FirstEnergy Nuclear Operating Company

Davis-Besse Nuclear Power Station, Unit 1
Docket No. 50-346, License No. NPF-3
Response to Request for Additional Information Regarding Measurement
Uncertainty Recapture Power Uprate Amendment Application (TAC No.
MD5240)

Response to Request for Additional Information Regarding Measurement
Uncertainty Recapture Power Uprate Amendment Application

Response to Request for Additional Information Regarding Measurement
Uncertainty Recapture Power Uprate Amendment Application
Page 1 of 18

**Figure 1 – Measured Velocity Profile for Serial Number 6764
Plant Loop B, from 4/3/07 through 12/26/07.
The leading edge flow meter (LEFM) was placed in
service on 4/3/07 and used as Heat Balance Input.**

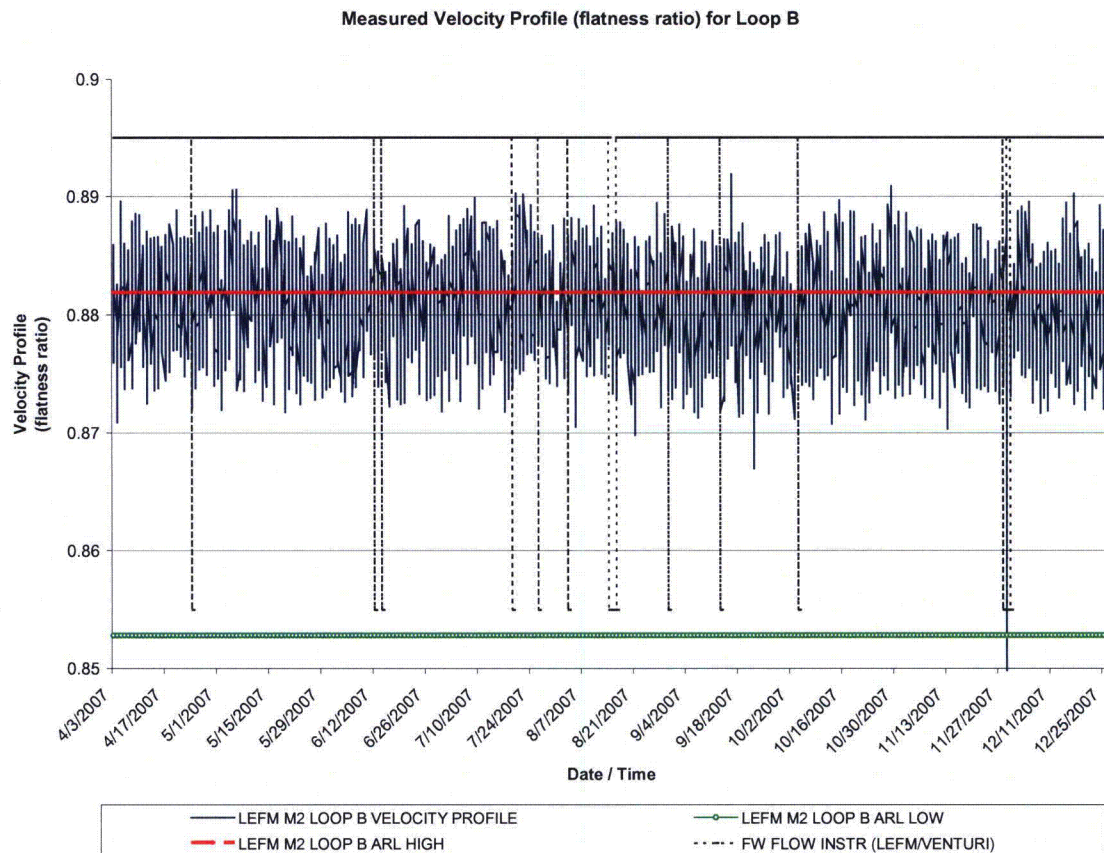
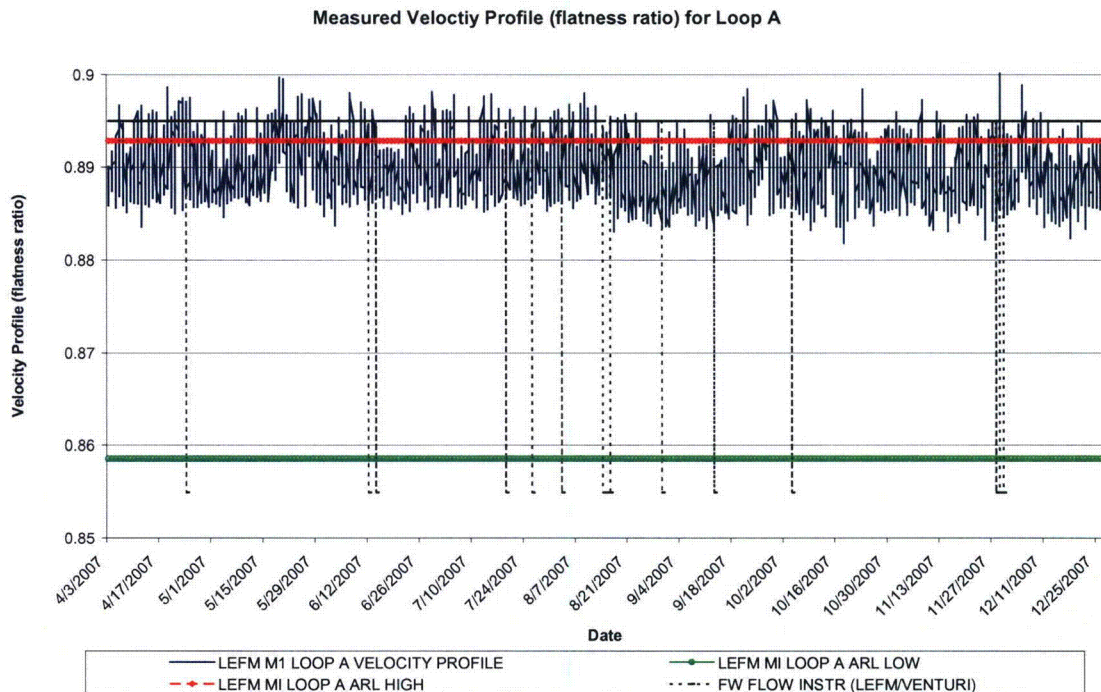
- 1. Provide representative flow profiles from plant operation that can be compared to the Alden Research Laboratory (ARL) test results provided in ER-227 Rev. 1 and the reasons for and implications of differences, if any.**

Engineering Report (ER)-227 Rev. 1 notes that Serial Number 6765 was installed in Loop A at the plant and Serial Number 6764 was installed in Loop B at the plant. Figure 1 and Figure 2 display the measured velocity profile flatness ratio for Serial Number 6764 and 6765, respectively. The graph also displays the ARL span of calibration for flatness ratios for each pipe as summarized in Table 1. The calibration profile flatness ratio span for Serial Number 6764 at ARL as reported in ER-227, "Profile Factor Calculation and Accuracy Assessment for the Davis Besse Unit 1 LEFM $\sqrt{+}$ Spool Pieces," Rev. 1, was 0.8528 to 0.8819. The span of calibration profile flatness ratios (FR) for Serial Number 6765 at ARL as reported in ER-227 Rev. 1 was 0.8586 to 0.8929. During the period of time from 4/3/07 to 12/26/07, the operating span of flatness ratio for Serial Number 6764 at the plant was 0.8670 to 0.8919. The span of operating profile flatness ratio for Serial Number 6765 at the plant was 0.8818 to 0.8997. The data is summarized in Table 1.

The plant profiles in Figures 1 and 2 overlap the ARL calibration profiles, and the span of plant profiles are within the span of the tested ARL calibration profiles.

As discussed in ER-80P, "Improving Thermal Power Accuracy and Plant Safety While Increasing Operating Power Level Using the LEFM $\sqrt{T}$ System," a velocity profile upward shift is an expected response once the meters are moved from the test laboratory and installed within the plant. In the test laboratory, the profile factor is determined to ensure that the meter's accuracy is maintained by correcting the actual plant flow velocities. The profile factor correction of the actual plant flow velocities operating span is within the calibration span of the ARL results. Therefore, there is confidence that the ARL calibration results apply to plant conditions.

In Figure 1 and Figure 2, transducer replacements and other instances of transducer maintenance are denoted by vertical lines in the graphs. Historical transducer replacements are listed in Table 2. The response to Question 6 contains additional information relevant to transducer replacement periods.

Some changes in measured flatness ratio could be attributed to transducer replacements, but the changes in measured flatness ratio do not always occur after transducer replacement. The changes in the flatness ratio are small in any event, and are consistent with ER-551 Rev. 1, "LEFM $\sqrt{+}$ Transducer Installation Sensitivity," which reports the uncertainty associated with transducer replacement. In effect, the changes are within the observational uncertainty of the measurements.

Figure 3 – Measured Velocity Profile and LEFM Flow for Loop A, from 2/15/05 through 5/18/06.

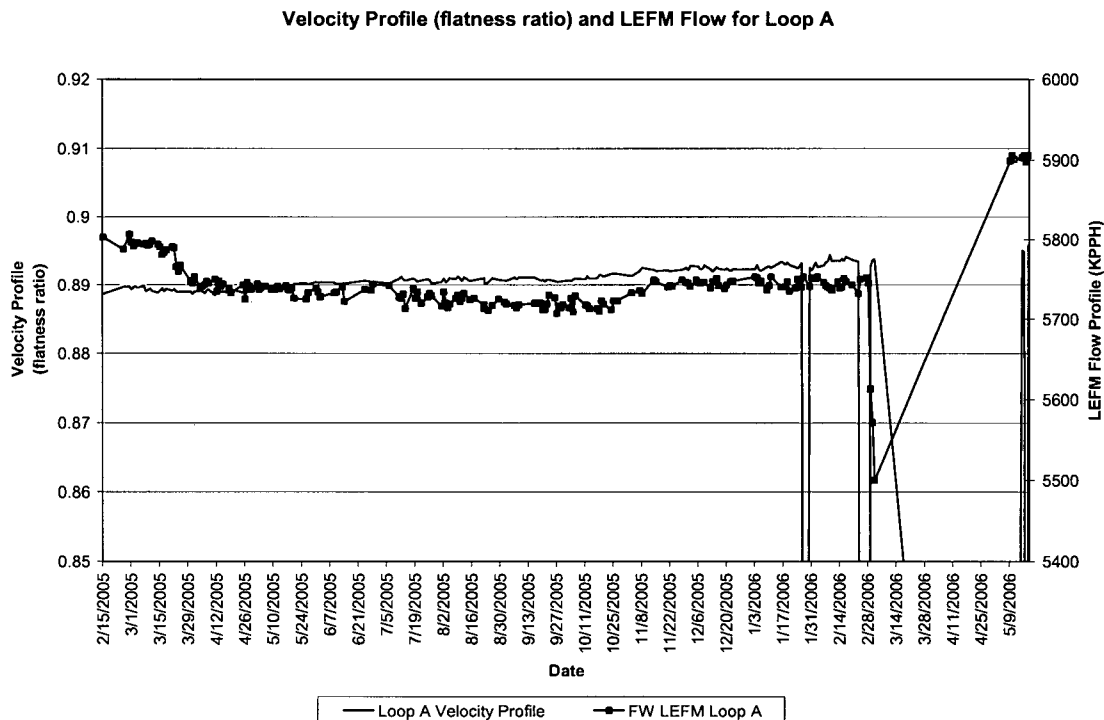
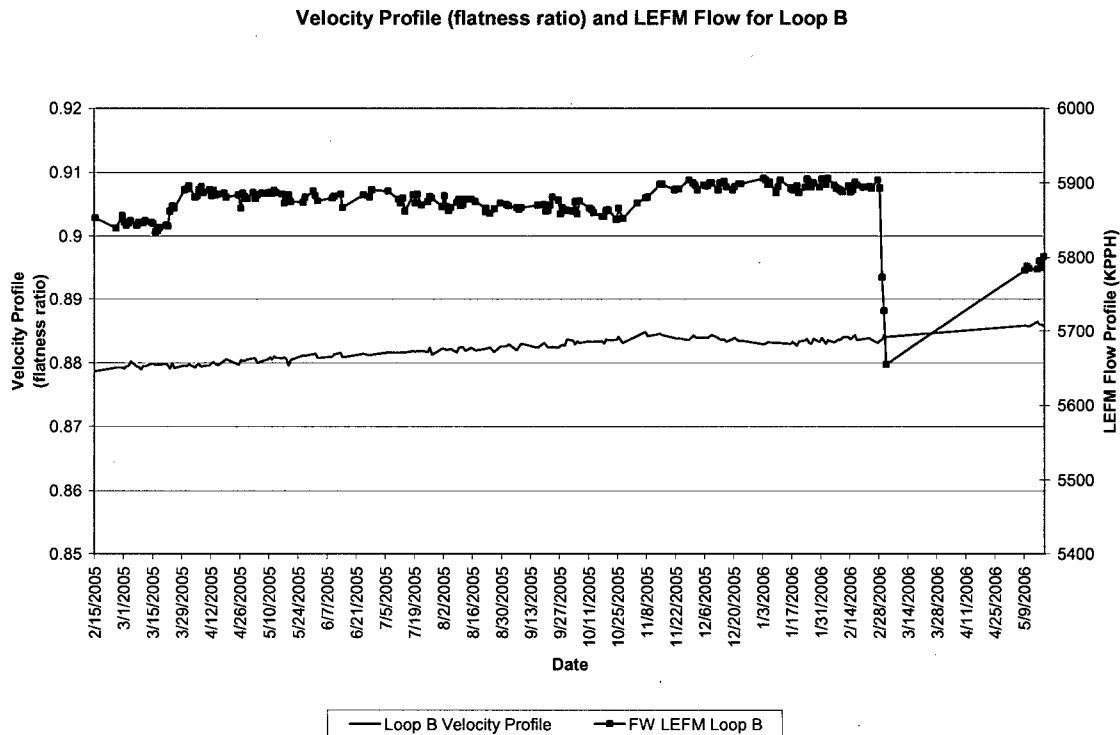
b. Describe the relationship between the information and the measured flow rate

Figure 3 and Figure 4 show that the flatness ratio is not correlated to measured flow rate at any discernable level. This is to be expected. As discussed in ER-262, "Effects of Velocity Profile Changes Measured In-Plant on Feedwater Flow Measurement Systems," a real change in flatness ratio would result in a real calibration shift of only $-0.0167\% \times \text{flatness ratio} + 1.0167$. The measured flatness ratio operating span for Loop A is 0.8885 to 0.8959 and for Loop B is 0.8787 to 0.8864 during the time period of 2/15/05 through 5/18/06. Since the measured flatness ratios shifted, the expected shift in calibration would be approximately -0.01% for Loop A and Loop B, which is beyond the ability of the measurements to discern and is overwhelmed by real fluctuations in flow rate that are commonplace in feedwater systems.

Figure 5 – Measured Velocity Profile for Serial Number 6764, Plant Loop B, from 2/15/05 through 5/18/06.

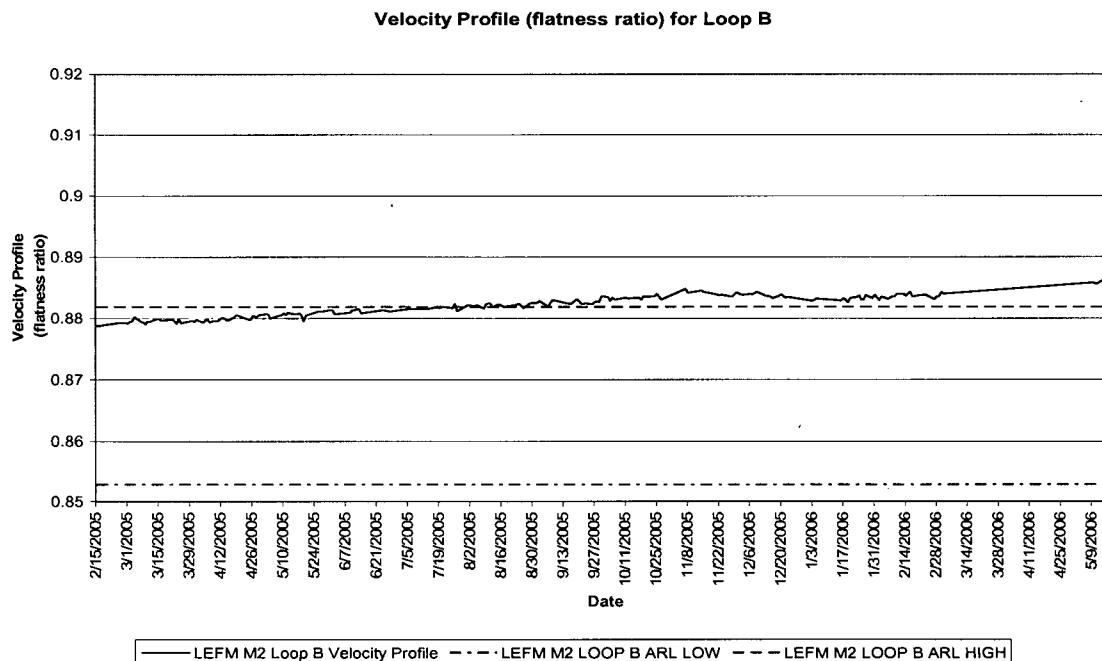
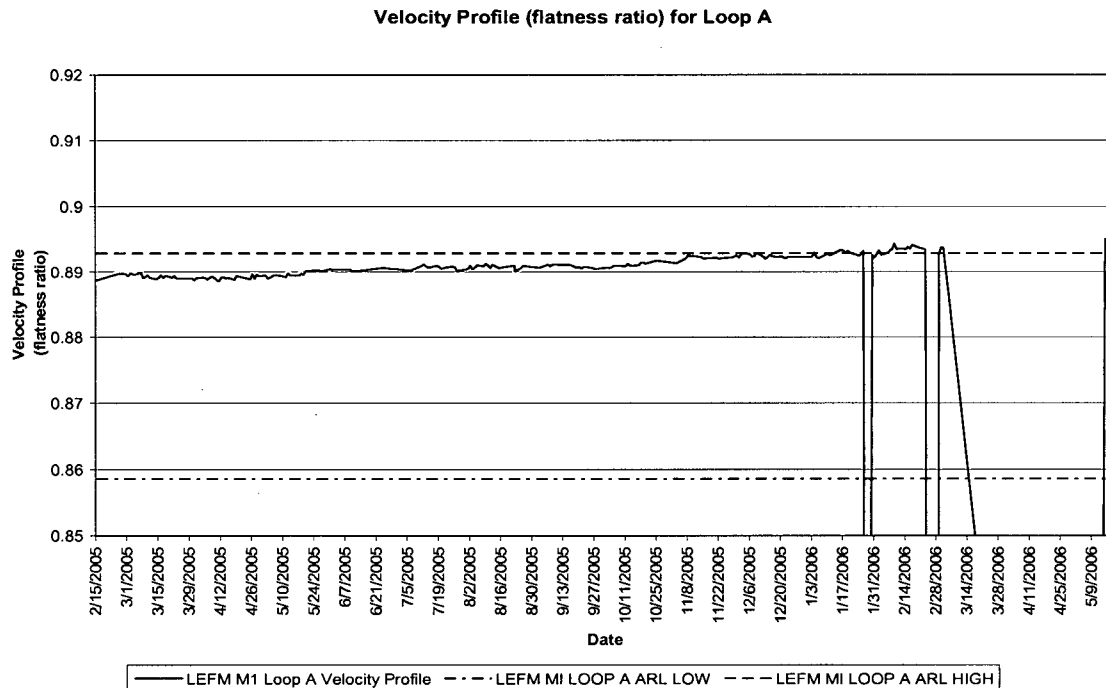
- c. Provide a comparison of the Page 16 information with Table 3 on Page 9 of ER-227 Rev. 1.**

Figure 5 and Figure 6 display the measured velocity profile flatness ratio for Serial Number 6764 and 6765, respectively, during the time span referenced in the figure located in Attachment 1 on Page 16 of the September 18, 2007 correspondence. Also shown on the graph and listed in Table 3 is the ARL span of calibration for flatness ratios for each pipe. The span of calibration profile flatness ratio for Serial Number 6764 at ARL that was reported in ER-227 Rev. 1 was 0.8528 to 0.8819. The span of calibration profile flatness ratios for Serial Number 6765 at ARL as reported in ER-227 Rev. 1 was 0.8586 to 0.8929. Also noted in ER-227 Rev. 1, Serial Number 6765 was installed in Loop A and the Serial Number 6764 was installed in Loop B. During the period of time from 2/15/05 to 5/18/06, the operating span of

The profiles in Figures 5 and 6 for the plant overlap with the profiles of the ARL calibration, and the span of profiles in the plant are within the span of profiles tested in the ARL calibration.

The data displayed in the figures show that prior to the changeout of the transducers in May 2006, the performance is comparable to the test data listed in Table 3 of ER-227. Therefore, there is confidence that the ARL calibration results apply to plant conditions.

Figure 7 – Measured Velocity Profile for Loop A before and after transducer replacement (May 2006)

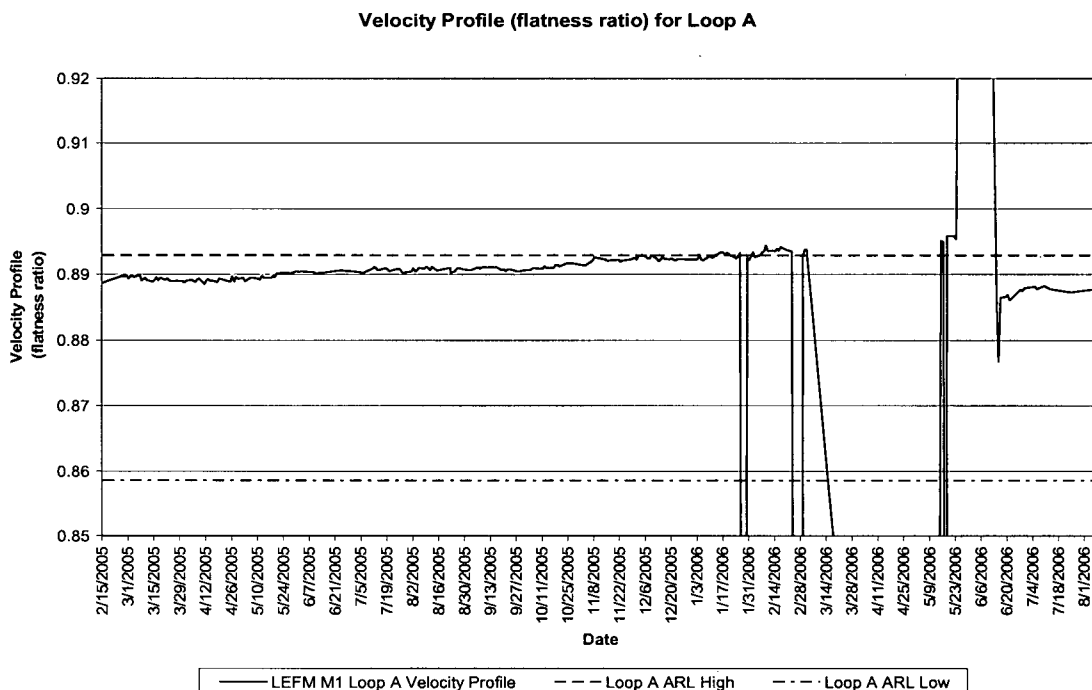
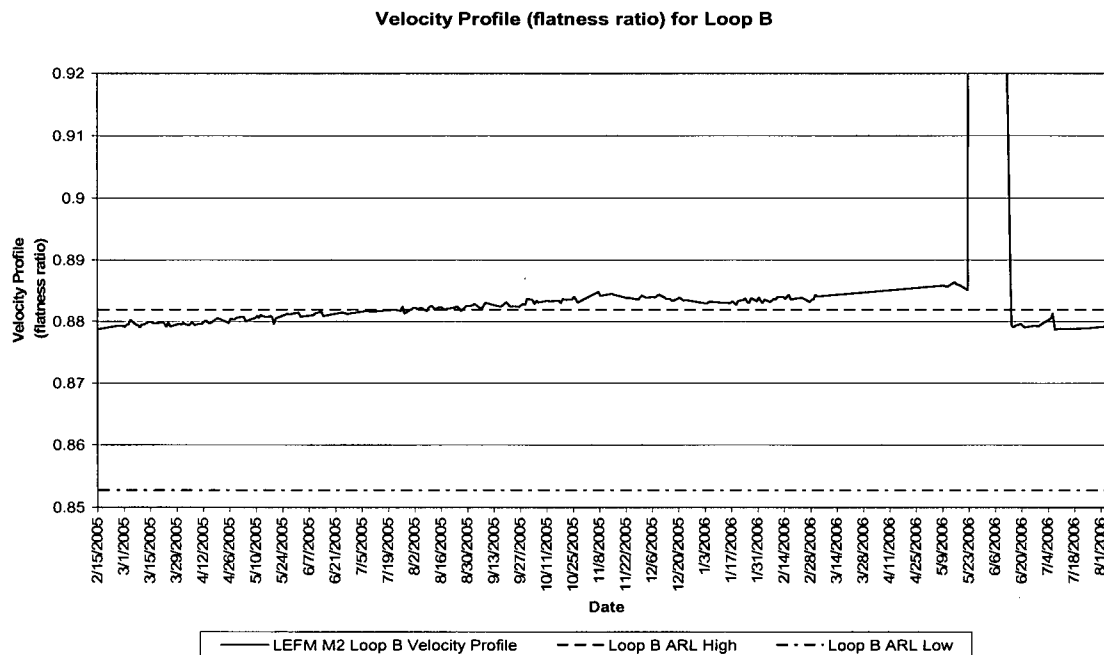
d. Coverage of Page 16 information versus operating history including from time of initial operation and after transducer replacement

Although the LEFM was installed earlier, it was not placed into service as the heat balance input until April 3, 2007. Since being placed into service, the transducers were replaced on multiple occasions. Some changes in measured flatness ratio could be attributed to transducer replacements, but the changes in measured flatness ratio do not always occur after transducer replacement. The changes in flatness are small in any event, and are consistent with ER-551 Rev. 1, "LEFM CheckPlus Transducer Installation Sensitivity," which reports the uncertainty associated with transducer replacement. In effect, the changes are within the observational uncertainty of the measurements and consistent within the uncertainty analysis allowances.

Figure 7 and Figure 8 display the velocity profiles before and after transducer replacement for LEFM Loop A and LEFM Loop B in May 2006. The replacement of the LEFM transducers resulted in a minimal change in flatness ratio for LEFM Loop A and LEFM Loop B. The Loop A approximate average velocity profiles before and after transducer changeout were 0.8933 and 0.8875, respectively. The Loop B approximate average velocity profile before and after Loop B transducer changeout were 0.8836 and 0.8795, respectively. As discussed in ER-262, "Effects of Velocity Profile Changes Measured In-Plant on Feedwater Flow Measurement Systems," a real change in flatness ratio would result in a real calibration shift of only $-0.0167\% \times \text{flatness ratio} + 1.0167$. Since the measured flatness ratio shifted, the expected shifts in meter calibration would be $+0.01\%$ for Loop A and Loop B. These shifts are not discernable measurements and are overwhelmed by normal feedwater system fluctuations. The minor shift in flatness ratio from pre-maintenance levels in both meters can not be determined with certainty that it was caused by the LEFM transducer replacements or by other combined effects external to the LEFM. The measured velocity profile, as displayed in Figure 7 and Figure 8, overlaps with the profile as determined by the ARL calibration. The span of the velocity profile for the meter installed in the plant is within the span of profile tested in the ARL calibration, before and after the transducer changeout. Therefore, there is confidence that the accuracy of the LEFM is not compromised by a replacement of the transducers.

**Figure 9 –Velocity Profile for Loop A and Loop B,
from 2/15/05 through 5/18/06.**

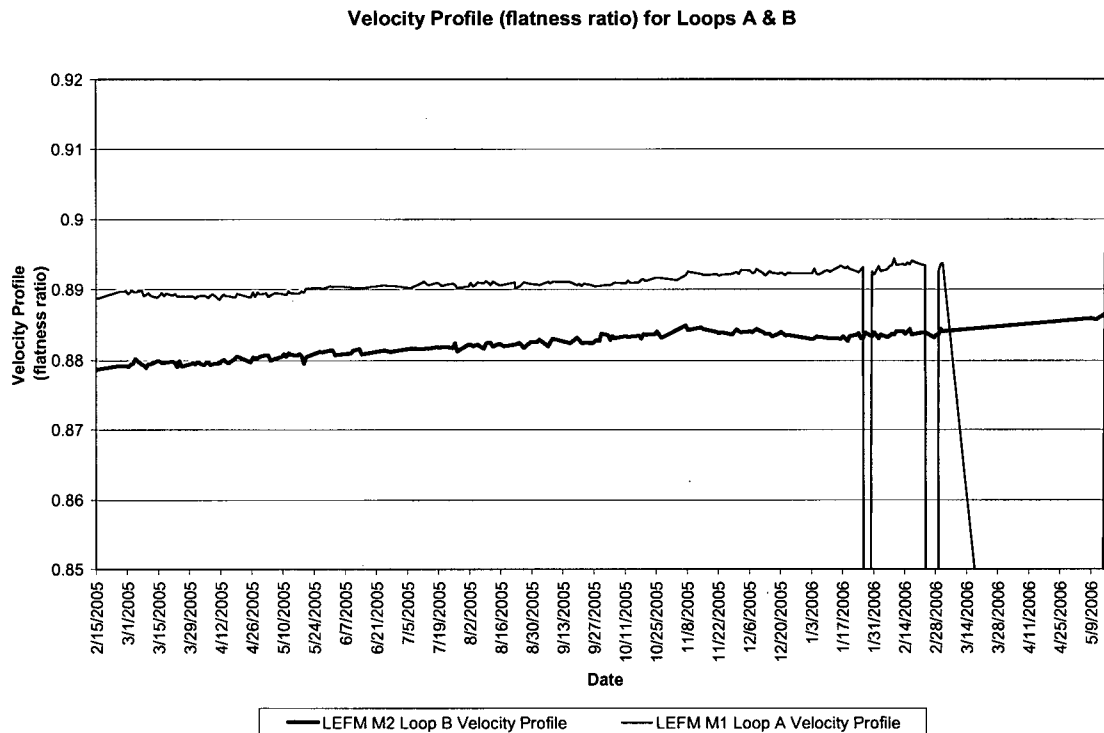
- e. Provide reason for correspondence between the “ups and downs” in the Page 16 plots for the two pipes**

The apparent correlation between the measured flatness ratios in Loop A and Loop B in Figure 9 suggests changing feedwater profiles in response to plant power or regulation valve positions. However, it is not unreasonable to expect that changes in pipe wall roughness would be similar between the pipes since chemistry and iron transport conditions would be the same in each pipe. Different pipes in the same feedwater systems have exhibited both correlated and uncorrelated behavior in the past, as noted in ER-262 Rev. 0, “Effects of Velocity Profile Changes Measured In-Plant on Feedwater Flow Measurement Systems.” Therefore, in this time period and in this instance, the flatness ratios are correlated and the result of systematically related changes. However, because the changes are small and within the limits of the ARL, which bounds the allowances, the uncertainty analyses remain acceptable.
